# ROAD SAFETY AUDIT

HIGH STREET FROM MAIN STREET (ROUTE 27) TO  
POWDER MILL ROAD (ROUTE 62)

ACTON, MA

MAY 18, 2021

**Figure 3: High Street at Faulkner Hill Road and Audubon Drive**

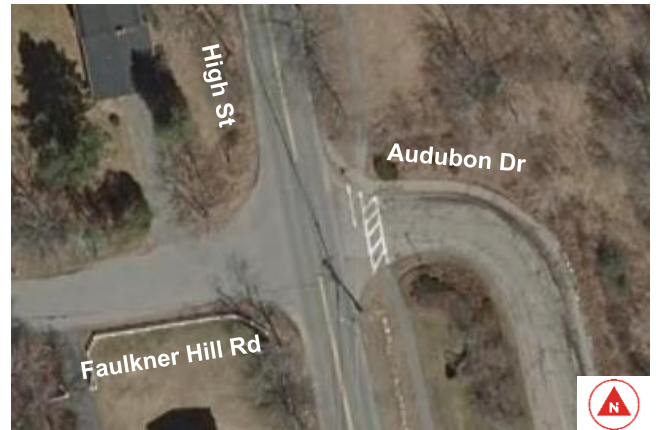
Audit members noted that Faulkner Hill Road had a stop sign which seems to have been taken down which adds to confusion for people looking to pull out to High Street. Additionally, sightlines exiting Faulkner Hill Road were noted to be limited.

Audit members and public feedback respondents noted that this intersection is popular for people walking and biking since it links to the Pratts Brook Conservation Area and is close to Main Street for commuter rail access. Many people mentioned increased vehicle speeds as vehicles come downhill making this intersection dangerous to cross.

- Explore installing a stop sign on Faulkner Hill Road.
- Evaluate sight triangles at this intersection.

- Consider implementing traffic calming measures including median islands and signage to reduce speeds through the intersection.
- Consider installing a crosswalk with flashing beacons/RRFBs. The installation of RRFBs should only be considered in conjunction with the aforementioned speed management/traffic calming measures.

Figure 10: High Street crash locations

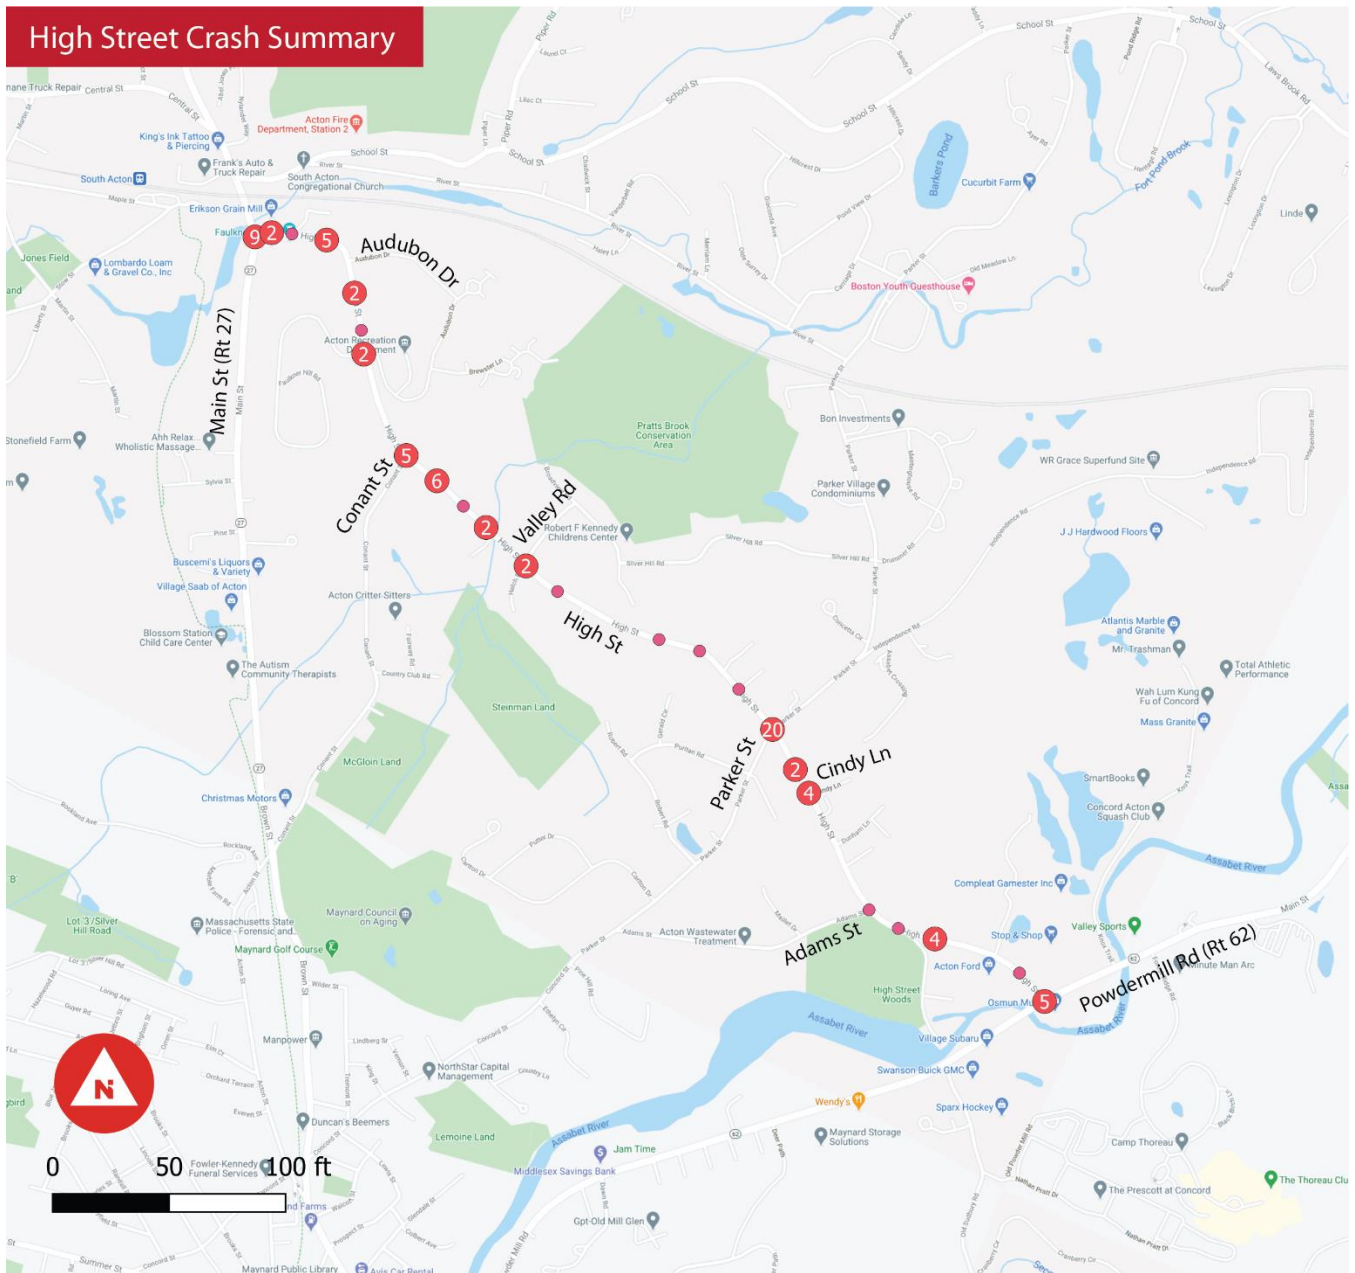
**Figure 10** shows where the crash clusters are located within the corridor. Most of the collisions happened near Parker Street and Main Street intersections, representing 25% and 14%, respectively.

This intersection has the highest number of crashes (25% of total) in the corridor. Many people had specific concerns of visibility at this intersection due to overgrown vegetation. It was mentioned that drivers on Parker Street do not see the stop sign at this intersection and also not see cars travelling on High Street.

- Evaluate sight triangles at this intersection.
- Reevaluate the trimming schedule for vegetation at this intersection.
- Consider adding a mini traffic circle at this intersection.
